Process Sheet

Customer : CU-DAR001 Dart Helicopters Services Drawing Name : 205 SKIDTUBE "I" BEAM
Job Number : 35996
Estimate Number : 10346
P.O. Number : N/A Part Number : D2596
This Issue : 11/27/2007 S.O. No. : N/A Drawing Number : D2596 REV D
Prsht Rev. : NC Project Number : N/A
First Issue : N/A Type : LANDING GEAR Drawing Revision : D
Previous Run : 35995 Material : N/A
Written By : Due Date : 12/6/2007 Qty: 10 Um: Each
Checked & Approved By : 11/27/2007
Comment : Est: D 99-02.02 Changed QA to QC, Added Step 6 and Cost D
M
Est Rev:E 07-07-09 Incorporated DEO 9183 JLM

DART ENGINEERING ORDER

AMEND DRAWING D2580 REV. C TO ADD D2580-045 ASSEMBLY

DESIGN RF	DRAWN BY RF	DART AEROSPACE LTD HAWKESBURY, ONTARIO, CANADA	
CHECKED #	APPROVED #	DRAWING NO. DEO 9183	REV. B SHEET 1 OF 1
DATE 00.05.15		TITLE ADD SKIDTUBE P/N D2580-045	SCALE NTS
A	00.03.29	NEW ISSUE	
B	00.05.15	39.580 WAS 39.620

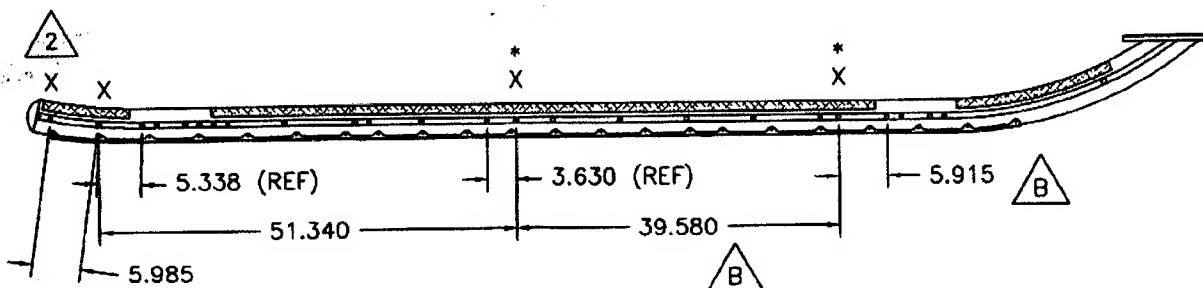
D2580-045 IS IDENTICAL TO D2580-041, EXCEPT FOR THE FOLLOWING CHANGES:

- 1) INSTALL CROSS BOLT SPACERS AT LOCATIONS MARKED 'X' ACCORDING TO THE FOLLOWING PROCEDURE.
 - a) DRILL $\varnothing 0.508$ HOLES AT LOCATIONS SHOWN BELOW MARKED 'X'.
CHAMFER HOLES $0.030 \times 45^\circ$. NOTE THAT HOLES WILL ALSO HAVE TO BE TRANSFERRED TO THE D2596 WEB AT THE * LOCATIONS. IT IS ACCEPTABLE TO PRE-DRILL THE D2596 WEB IN THESE LOCATIONS BEFORE INSTALLING THE WEB IN THE SKIDTUBE. OPEN HOLES TO $\varnothing 0.63$ AND TOUCH UP WITH ALODINE PER QSI 005 4.1.

- b) INSERT D2579 CROSS BOLT SPACERS INTO THE HOLES.
 - c) WELD INTO PLACE PER DART QSI 004 AND GRIND FLUSH.
 - d) REMOVE SPILL OVER LEAVING HOLE DIMENSION $\varnothing 0.380$ - $\varnothing 0.390$.

- 2) IT IS ACCEPTABLE TO GRIND A RELIEF IN THE D2855 AFT CAP TO PREVENT INTERFERENCE WITH THE SPACER AT THIS LOCATION.
- 3) POWDER COAT ENTIRE ASSEMBLY GREEN (REF. 4.3.5.8) PER DART QSI 005 4.3 INSTEAD OF WHITE (REF. 4.3.5.1).
